VILLAGE BOARD AGENDA

- b. First Amendment of Development Agreement- Footworks Dance Company
 - c. Change Request #6 to SMA Construction Services in the amount of \$-10,458.00 for the Kimberly Street & Parks Dept. Building

- d. Change Request #7 to SMA Construction Services in the amount of \$9,954.32 for the Kimberly Street & Parks Dept. Building
 - e. Application for Temporary Class "B" Beer license- Kimberly Baseball Organization for Sunset Classic Tournament June 20-22, 2025 (Danielle Eckes, Agent)

P202

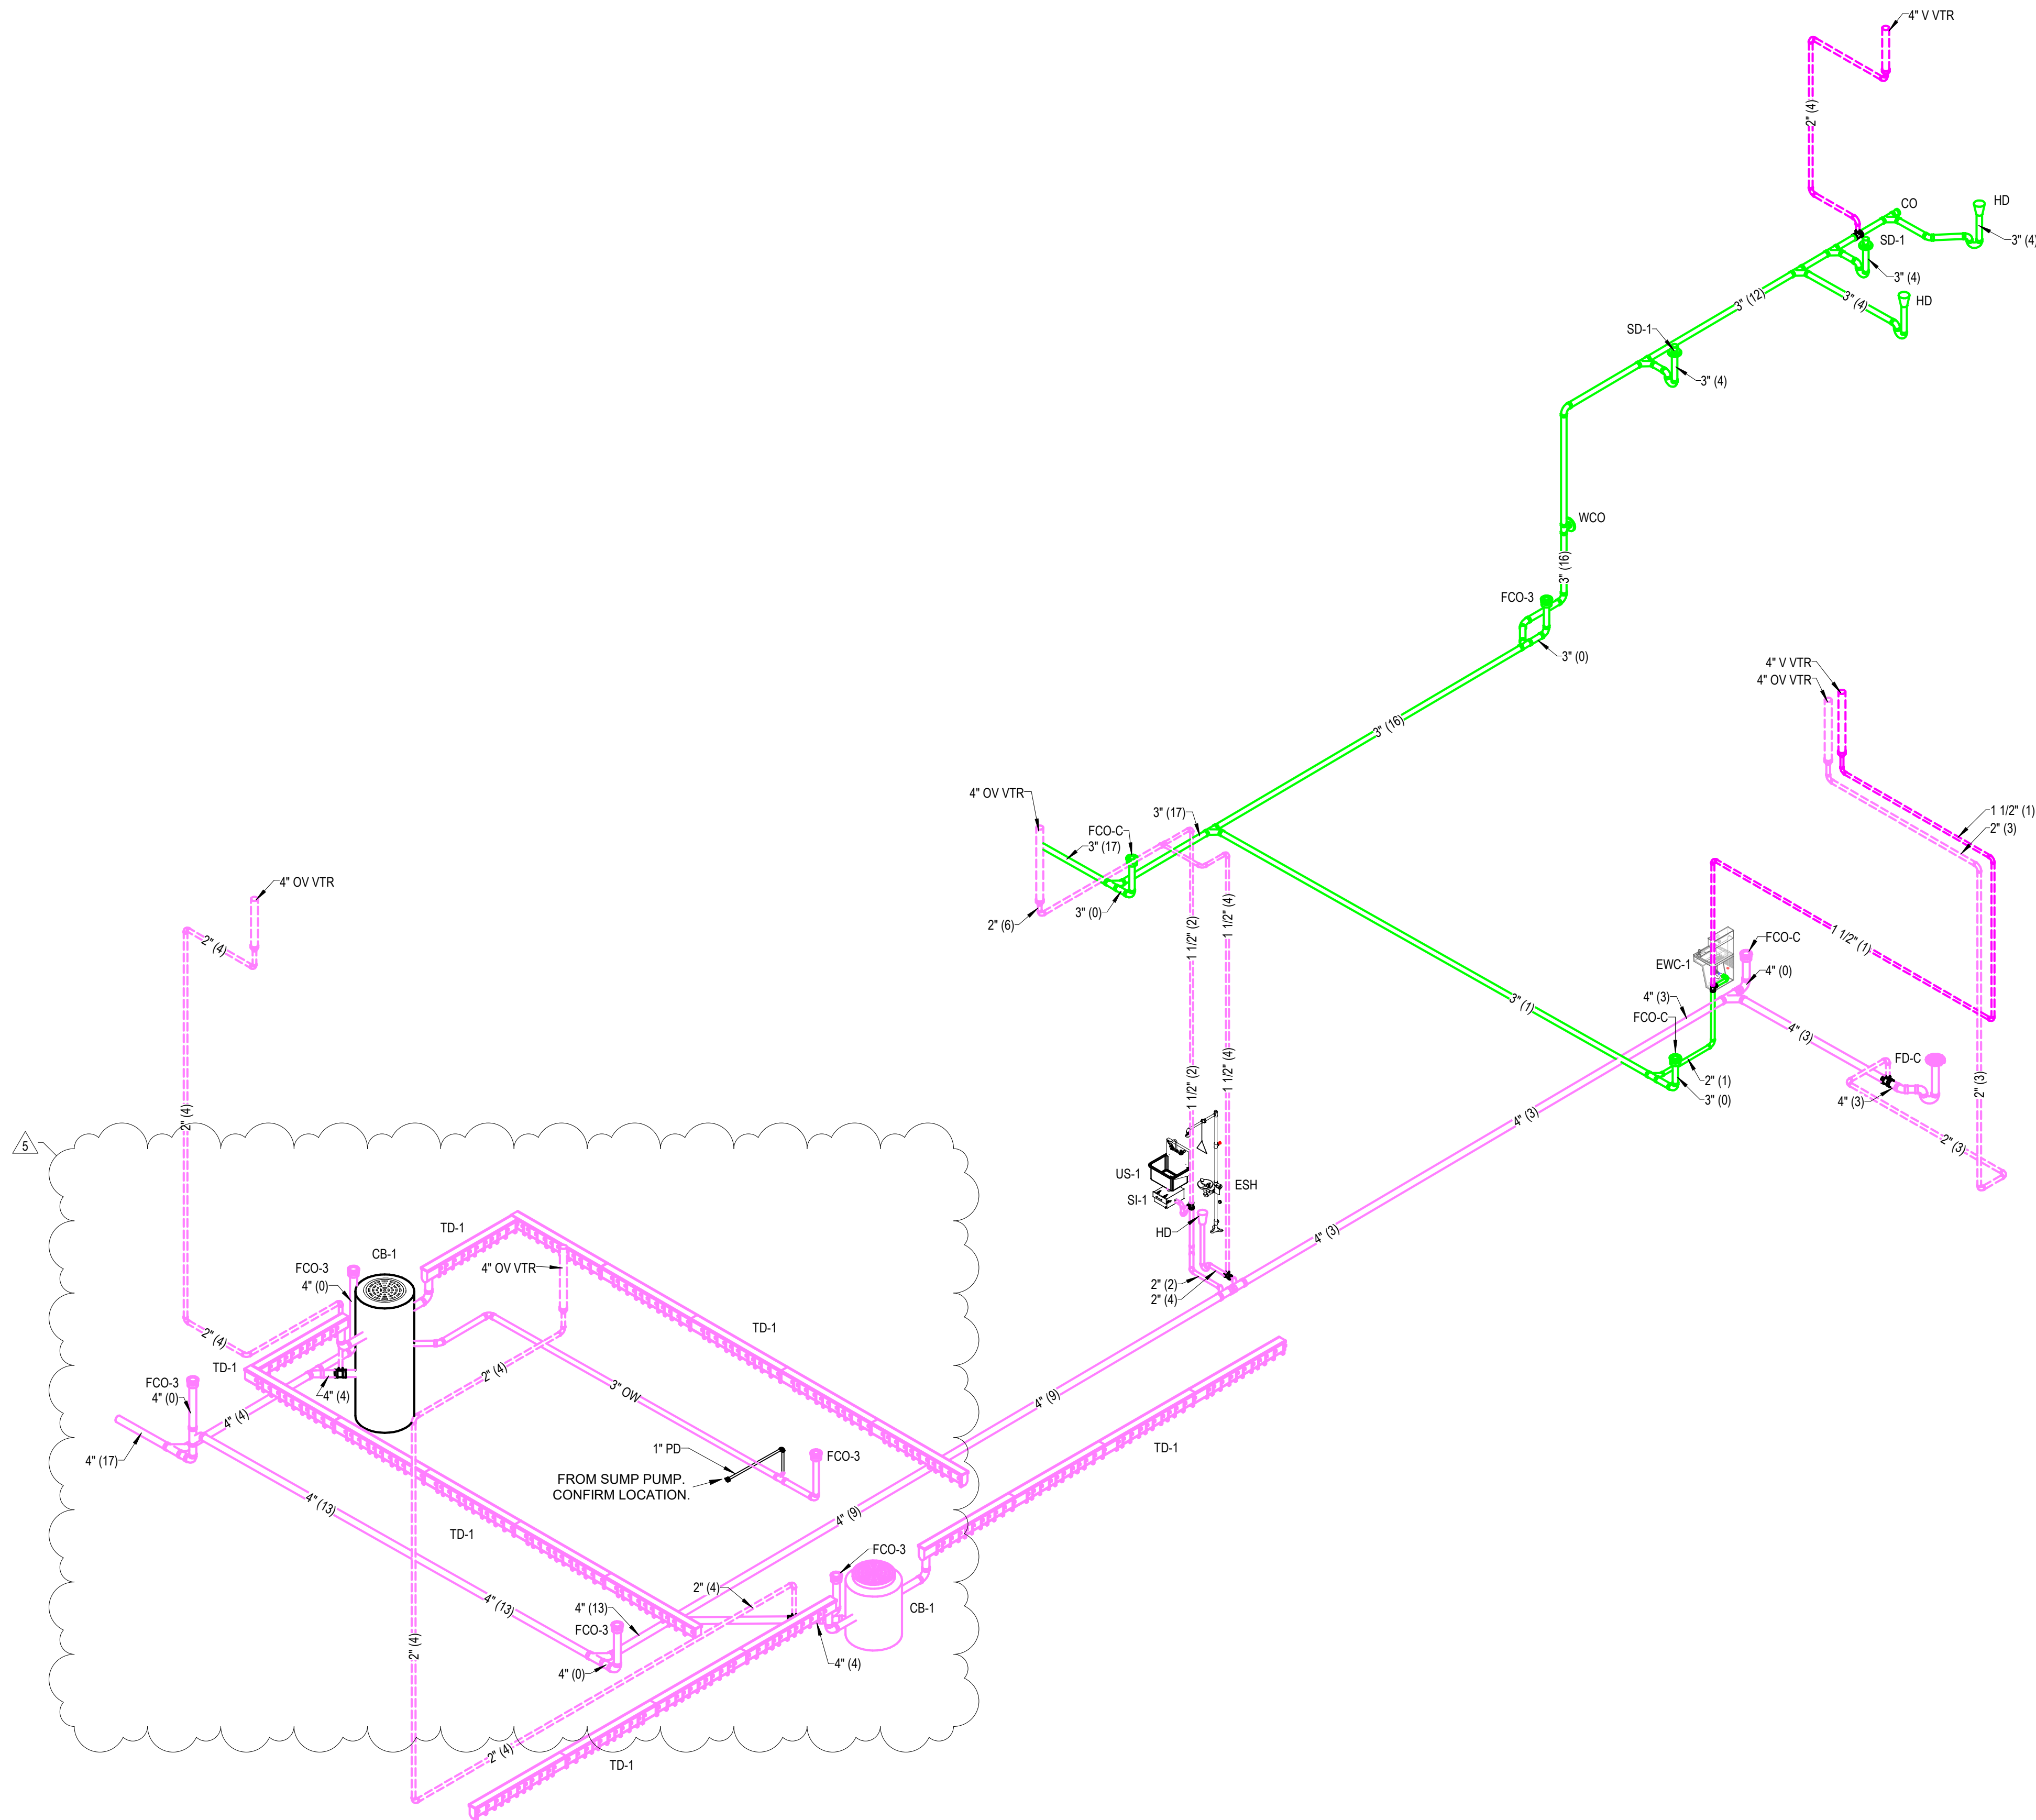
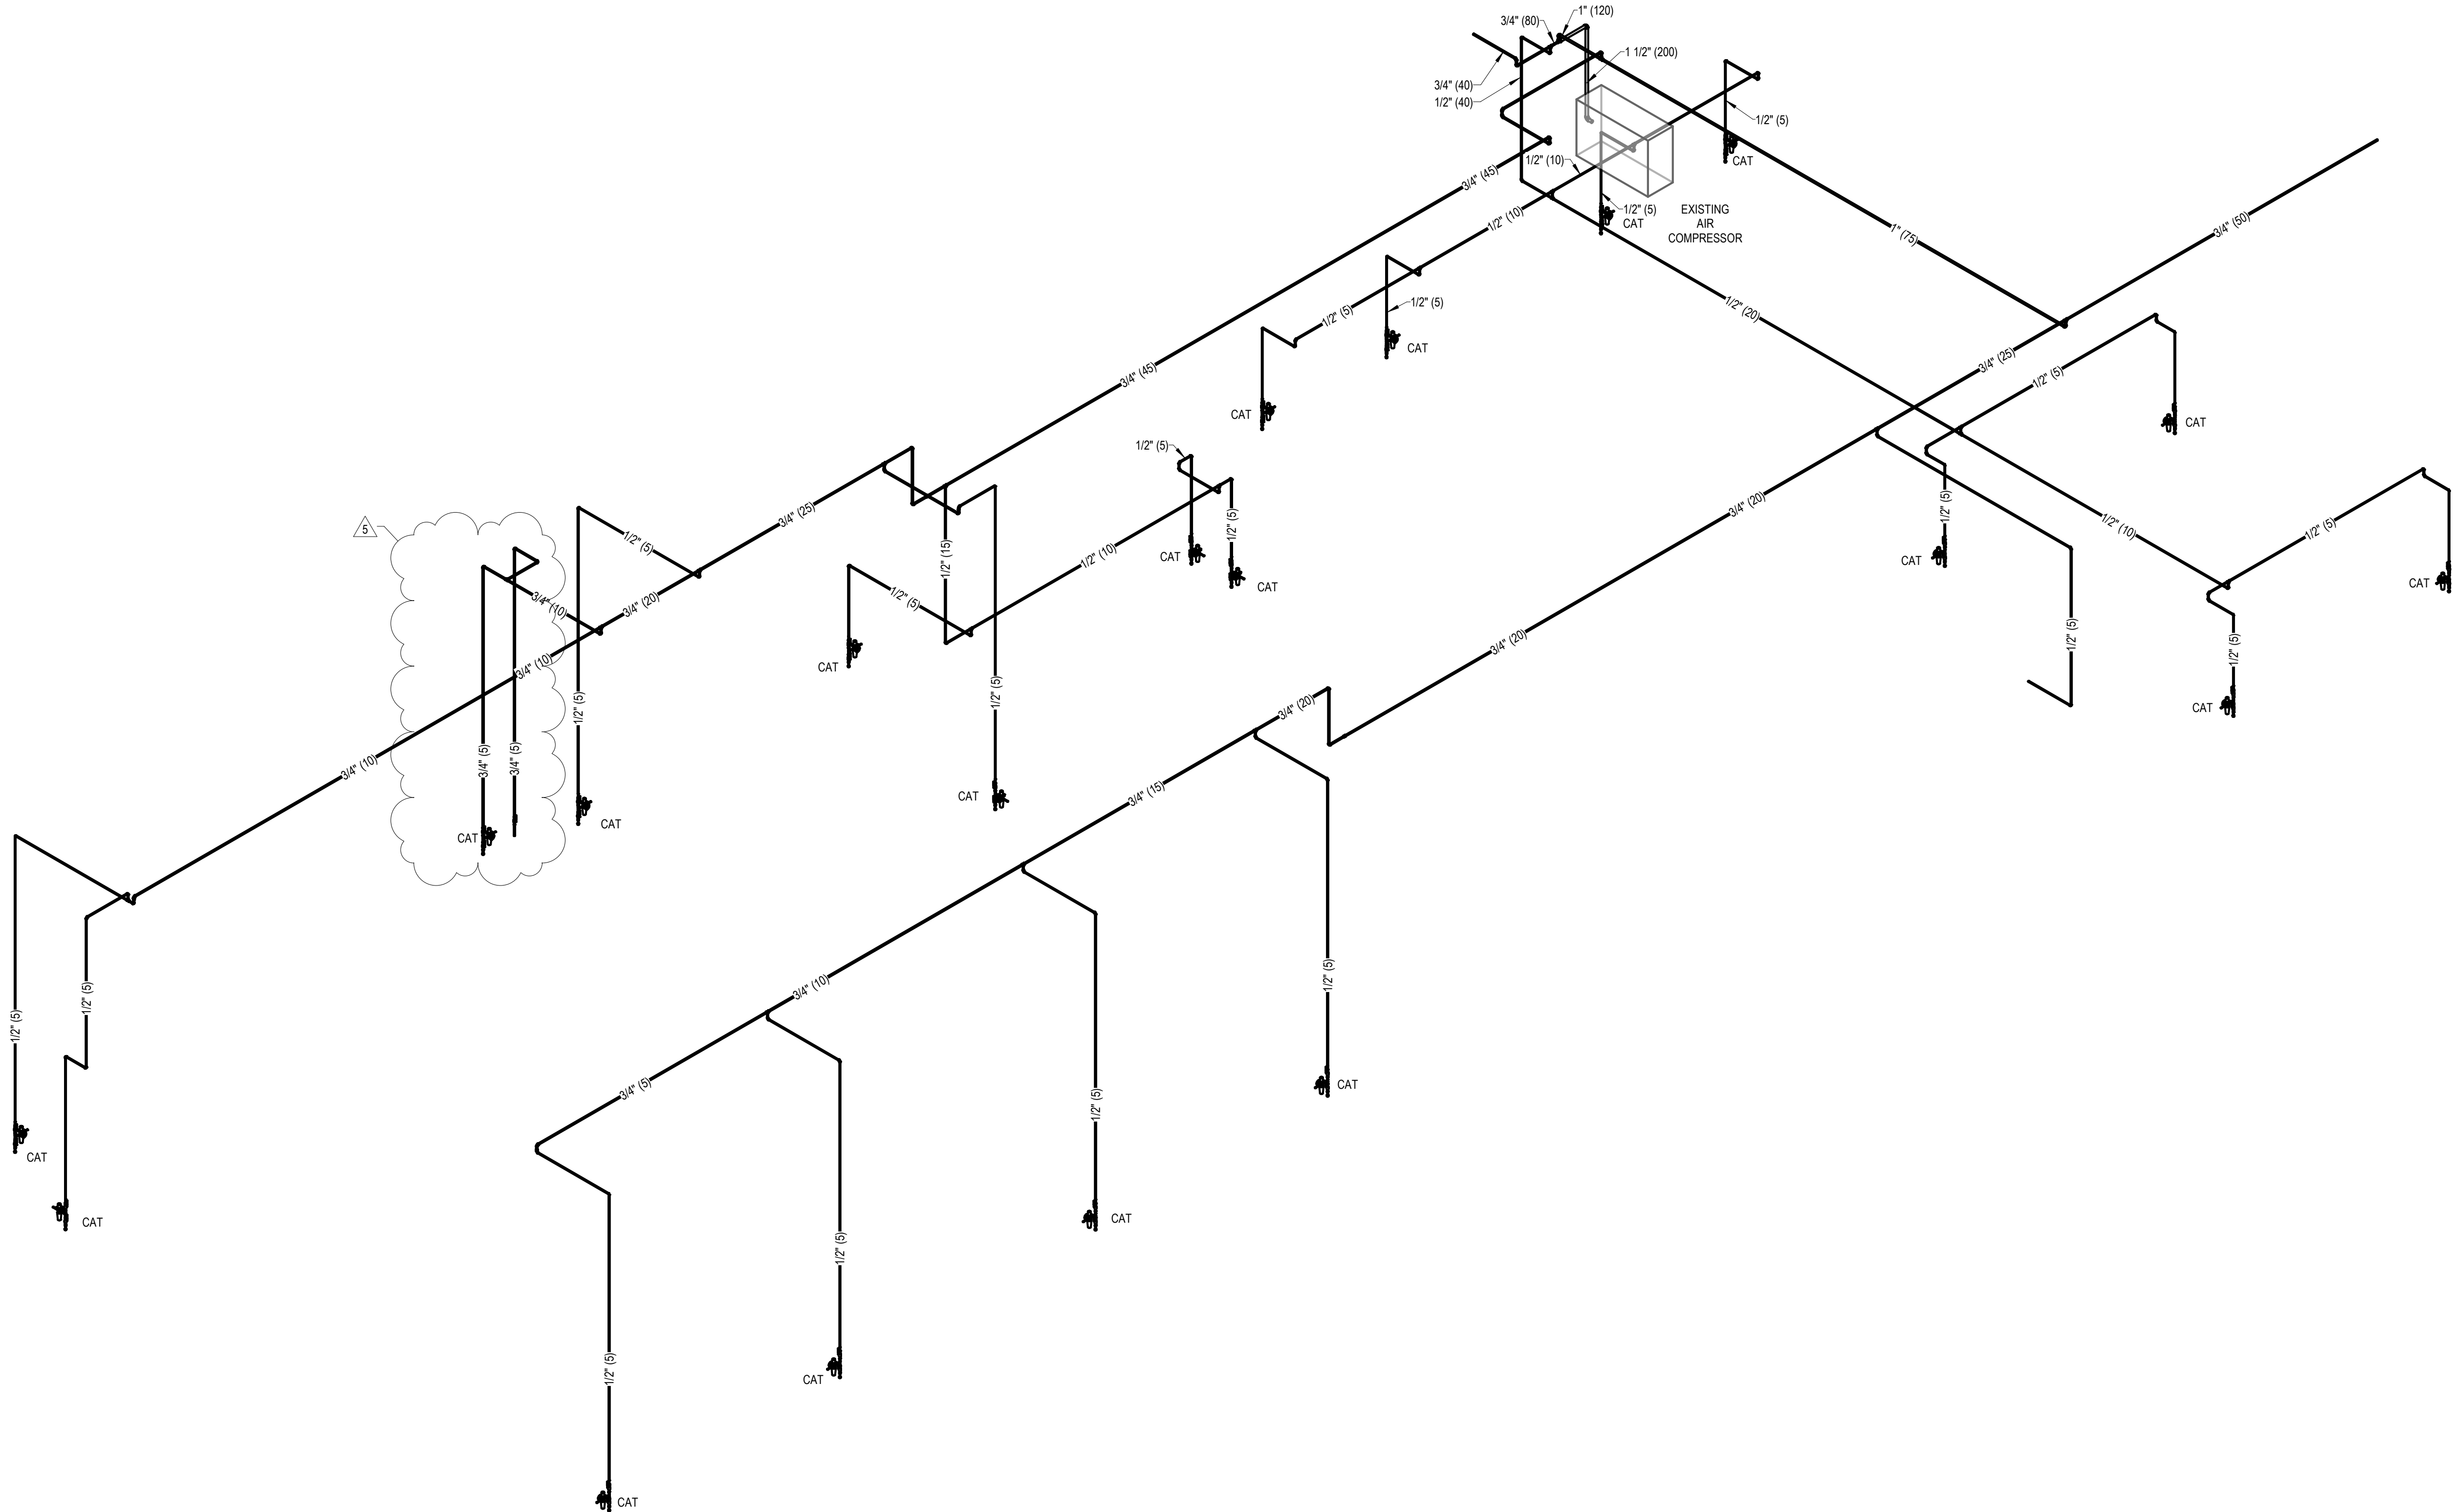
QUESTION: Please find the attached from EGI Mech. to clear up plumbing related items for the ECO Lift system install. Plans provided by ECO Lift and plumbing shown on contract drawings are in conflict with one another. We would request clarifications be made by plumbing designer and a sheet re issued to show needed construction up to the lift pit for coordination. Further details are included in EGI's RFI attached.

- 1) Is the 4" gravity drain required?
- 2) Plumbing drawings do not show the discharge line from pump at Page 6 of 7 - please provide size and connection point to OW system.
- 3) P102/Note 137 states valve and cap at 4' AFF. Ecolift drawing 5 of 7 shows Filter/Regulator/Lubricator (by others). Whom shall furnish this equipment? If EGI, can you please provide specifications.
- 4) P202/Note 137 - Can the 3/4" CA drop be relocated to East side of door to be adjacent to Control Console? Pending confirmation on location of Console.
- 5) Drawing set indicates (1) 2" sleeve from before mentioned 3/4" CA drop to Control Console. Ecolift drawings show (2) additional 4" SCH40 PVC chase runs and potential sleeve for CA to sump pit pump. Please confirm EGI shall install the additional 4" and CA to pump sleeving. CA line size to pump also. Thank you.
